UNITED STATES PATENT AND TRADEMARK OFFICE

Office Action Summary

10/694,029

This is the first Office Action for application number 10/694,029 Display Apparatus, filed on 10/28/03. Claims 1-41 are pending.

Fig. 2a

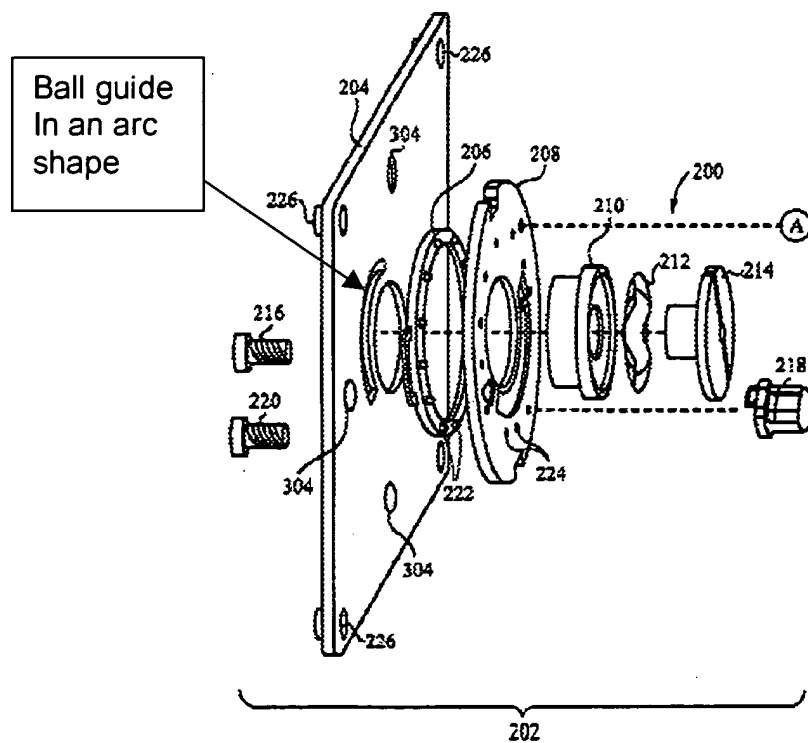
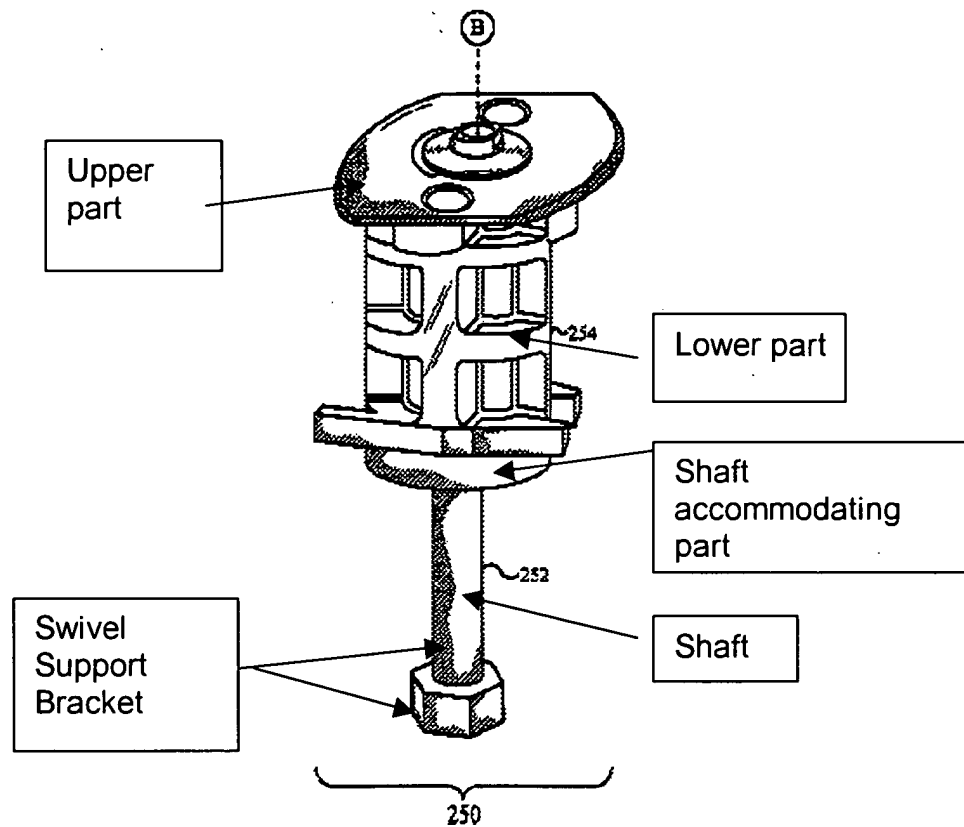
The patent to Bergeron Gull et al. discloses a display apparatus (100), that includes a display body (102), a stand (108) and an hinge assembly (200), located between the display body and the stand, the hinge assembly (200) rotating the display body about first, second and third perpendicular axis (See Fig. 1, 112, 114 and 116 indicate rotation of the display device). Bergeron Gull et al. teaches that the hinge assembly has a pivoting hinge (200, See Fig. 2a) which pivots the display body about a first axis which is perpendicular to the display body and pivots the display body relative to the stand (108) and is provided between the display body and the tilting hinge. Bergeron Gull et al. teaches that the hinge assembly has a swiveling hinge (250) that rotates the display body about a second axis which is perpendicular to the stand and swivels the display body relative to the stand, and is provided between the tilting hinge (200) and the stand (108), and a tilting hinge which tilts (200, See Fig. 2b) the display body around an axis which is perpendicular to the first and second axis and tilts the display body relative to the stand (108) and is provided between the display body (102) and the stand (108). Bergerson Gull et al. also discloses wherein the pivoting hinge (200) has a pivoting bracket (204) engaged to the display body and a brass or plastic (See Col. 5, lines 60 and 61 for material selection) pivoting support bracket (208, 218) that rotationally engages the pivoting bracket (204) and engages the tilting hinge and a pivot shaft (214) which projects from the pivoting bracket toward the pivoting support bracket. Bergeron Gull et al. shows a ball flange (206) located eccentrically from a

pivoting axis and a ball guide part in the shape of a circular arc (See Drawing Below) having a predetermined angle including a 90 degree angle, recessed from the surface of the pivoting bracket, wherein the location of the ball guide part corresponds to the ball flange.

*Fig. 2c*

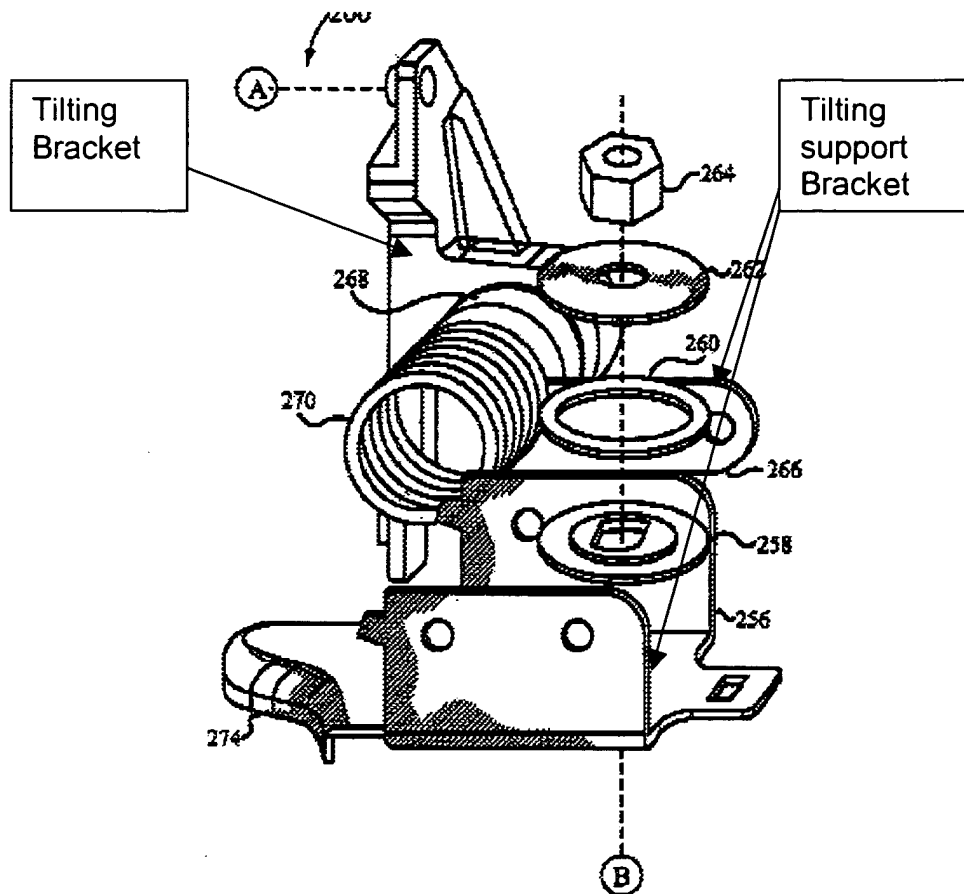
Bergeron Gull et al. discloses wherein the swiveling hinge (250, See Fig. 2c) has a swiveling support bracket (252) which is engaged to the stand and a swiveling bracket which has a lower part (254) swivelably engaged with the swiveling support bracket and an upper part (See Drawing Below) engaged with the tilting hinge, the swivel hinge

having a swiveling shaft that projects from the swiveling support bracket toward the swiveling bracket and the swiveling bracket has a shaft accommodating part into which the shaft is inserted.

Fig. 4

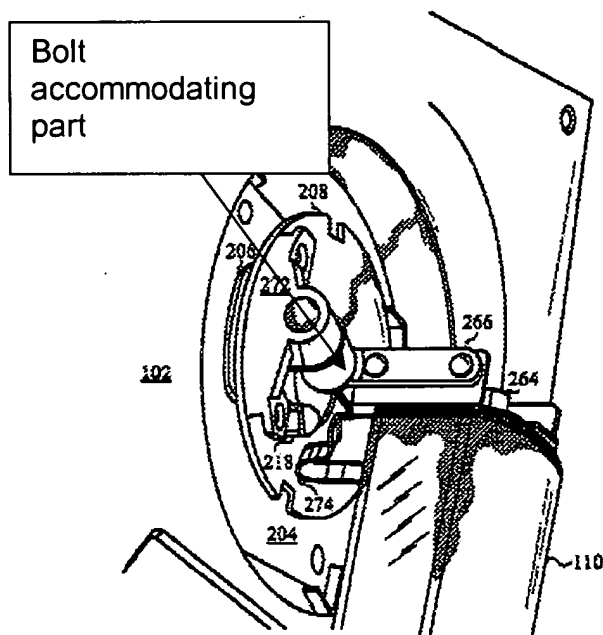
Bergeron Gull et al. shows the basic inventive concept as shown above including showing a tilting bracket (256, 266, See Fig 2b, note that only one side of the bracket is shown for simplicity, but that the teaching includes two sides as shown by Fig. 4) with

two ends (266), each having a bolt accommodating part (See Fig. 4 Below, See Col. 4 lines 39-51 for explanation of hinge) wherein the tilting bracket engages the tilting support bracket, the bolt accommodating parts align and an axle (268) passes through the bolt accommodating parts and a spring (270) giving a friction force between the tilting bracket and the tilting support bracket to secure the tilting bracket and the tilting support bracket together and rotate the display around the axle.

Bergeron Gull et al. does not show wherein the axle is a screw bolt and nut.

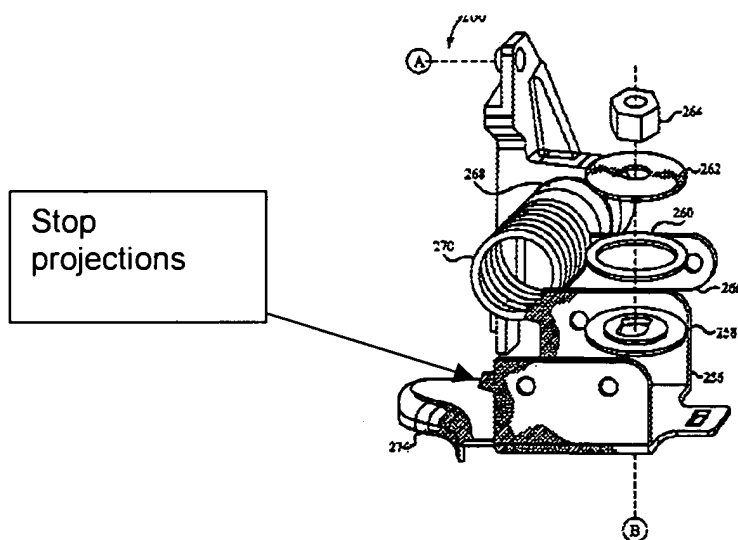
Bergeron Gull et al. and Kuhnke show the basic inventive concept as shown above and including that the tilting support bracket has a projection (See Drawing Below) for limiting the angle of the display, but they do not specifically show that the tilting bracket has a pair of stoppers each stopper having a face and a predetermined angle is formed between the faces, the projection being accommodated between the faces.
